Access Compliance Report

Public Rights-of-Way

(Curb Ramps)

Intersection ID: N/A	Main Street: BEREWICK_TOWN_CENTRE	Cross Street: CADEN_RD	Location: SW
ADA ID: 7C8D98A0A8AD	Ramp Type: Perp	Initial Pass/Fail: Fail	Overall Compliance: No
Severity Score: 1.25			
Codes/Mitigation Info/Possible Solution		Field Measurements/Component Compliance

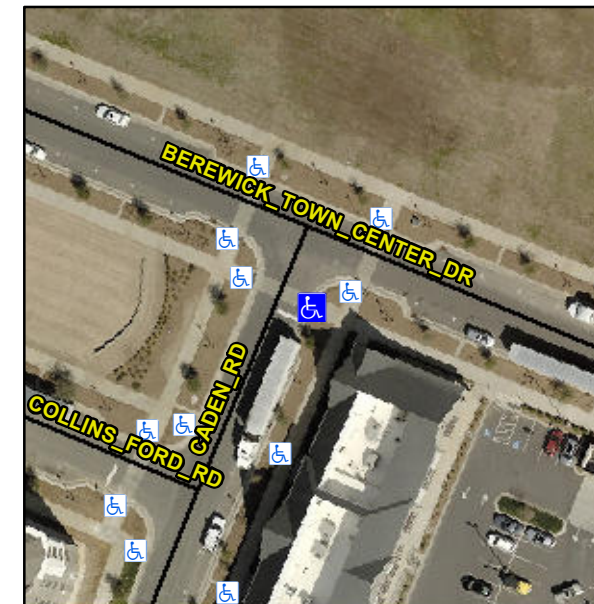
Not Found, R304.5.3

Compliance	Description	Data	Compliance	Description	Data
N/A	Ramp Length (in)	176.0	Yes	Ramp Slope (%)	6.5
Yes	Ramp Width (in)	94.0	No	Ramp XSlope (%)	2.4
N/A	Flare Type LT	N/A	N/A	Flare Type RT	N/A
N/A	Flare Slope LT (%)	N/A	N/A	Flare Slope RT (%)	N/A
N/A	Flare Traversable LT?	N/A	N/A	Flare Traversable RT?	N/A
N/A	Landing Length (in)	N/A	N/A	DWS Provided?	N/A
N/A	Landing Width (in)	N/A	N/A	DWS Contrast?	N/A
N/A	Landing Slope (%)	N/A	N/A	DWS Length (in)	N/A
N/A	Landing X Slope (%)	N/A	N/A	DWS Full Width?	N/A
N/A	Landing Curb? (Y/N)	N/A	N/A	DWS Offset (in)	N/A
N/A	Shared Landing?	N/A			
N/A	Gutter Ponding?	N/A	N/A	Gutter Slope (%)	N/A
N/A	Gutter Lip Ht (in)	N/A	N/A	Gutter X Slope (%)	N/A
N/A	Painted X Walk1?	Yes	N/A	Painted X Walk2?	N/A
	X Walk 1 Direction	To NW		X Walk 2 Direction	N/A
N/A	X Walk 1 Width (in)	98.0	N/A	X Walk 2 Width (in)	N/A
	X Walk 1 Slope (%)	1.1		X Walk 2 Slope (%)	N/A
	X Walk 1 X Slope (%)	1.7		X Walk 2 X Slope (%)	N/A

Remove & Replace Entire Ramp.
